**IN THE DRAWINGS:**

**REMARKS**

This amendment is in response to the Office Action of April 6, 2006.

Serial No. 10/791,191

**Fig. 5A**

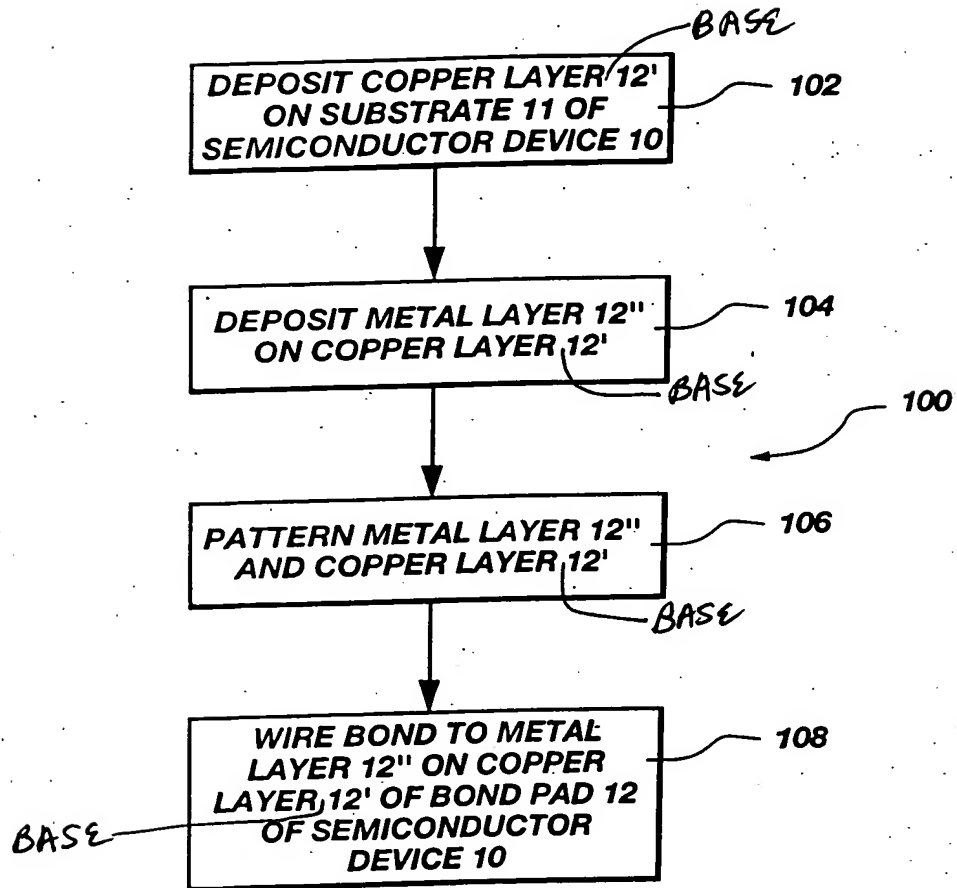
Specifically, FIG. 5A has been revised to insert the word **--BASE--** after the word **--LAYER--** and before the reference numeral **--12'--** on the first line of box 102, second line of box 104, second line of box 106 and third line of box 108; FIG. 5B has been revised to insert the word **--BASE--** after the word **--LAYER--** and before the reference numeral **--12'--** on the second line of box 204, second line of box 206, and third line of box 208; FIG. 5C has been revised to insert the word **--BASE--** after the word **--LAYER--** and before the reference numeral **--12'--** on the first line of box 302, second line of box 304, second line of box 306, second line of box 308 and third line of box 312; FIG. 5D has been revised to insert the word **--BASE--** after the word **--LAYER--** and before the reference numeral **--12'--** on the first line of box 402, second line of box 404, first line of box 408, and third line of box 410; FIG. 5E has been revised to insert the word **--BASE--** after the word **--LAYER--** and before the reference numeral **--12'--** on the first line of box 502, second line of box 504, first and fifth lines of box 508, and third line of box 510; FIG. 5F has been revised to insert the word **--BASE--** after the word **--LAYER--** and before the reference numeral **--12'--** on the first line of box 602, second line of box 604, second line of box 606, and fourth line of box 608; FIG. 5G has been revised to insert the word **--BASE--** after the word **--LAYER--** and before the reference numeral **--12'--** on the first line of box 702, first and second lines of box 704, second line of box 706, and fourth line of box 708; FIG. 5H has been revised to insert the word **--BASE--** after the word **--LAYER--** and before the reference numeral **--12'--** on the first line of box 802, second line of box 804, third line of box 806, second line of box 808, and fourth line of box 812; FIG. 5I has been revised to insert the word **--BASE--** after the word **--LAYER--** and before the reference numeral **--12'--** on the first line of box 902, second line of box 904, first line of box 908, and fourth line of box 910; and FIG. 5J has been revised to insert the word **--BASE--** after the word **--LAYER--** and before the reference numeral **--12'--** on the first line of box 1002, second line of box 1004, first and fifth lines of box 1008, and fourth line of box 1010.
